## LuK Service Info

# Visual features of LuK DMF

## External differences between LuK DMF and OE version

Art.-Nr.: 415 1078 09

Image 1: Visual comparison of LuK DMF (left) and OE DMF (right)

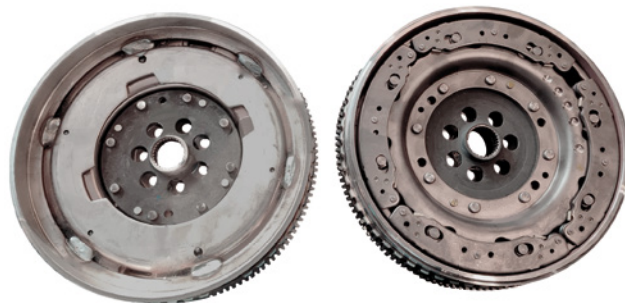
- the CPA system is located inside the DMF, unlike the OE version with an externally located absorber
- another shape of the primary mass outer ring

One of the striking examples is the LuK DMF Art.-Nr. 415 1078 09, which differs significantly from the OE versions (Image 1).

Despite the visual differences, the design of the LuK DMF Art.-Nr.: 415 1078 09 fully meets the technical requirements of the vehicle manufacturer and is able to completely replace the OE versions without any additional technical difficulties.
